Authorized Field Change

AFC 03904

Subject: Removal of Part Number 3566852C1 Certification Label on certain 9400i models built at Escobedo from 8/26/99 through 5/28/01

Model: 9400i

Figure 1 Navistar NETS Window

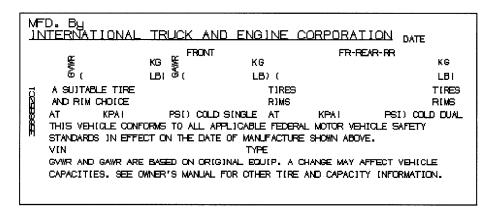
The vehicles identified above may have certification label 3566852C1 (see Figure 1) mistakenly installed on the inside door opening on the driver side. This label certifies that the vehicle conforms to all applicable U.S. Motor Vehicle Safety Standards. Because these vehicles do not have anti-lock brakes (ABS), the vehicle DOES NOT CONFORM to all U.S. Motor Vehicle Safety Standards.

All 9200 and 9400i models without anti-lock brakes (ABS) should be inspected for 3566852C1 certification label when the vehicle is brought in for service. If label part number 3566852C1 is found installed on a vehicle without anti-lock brakes (ABS), the label must be removed.
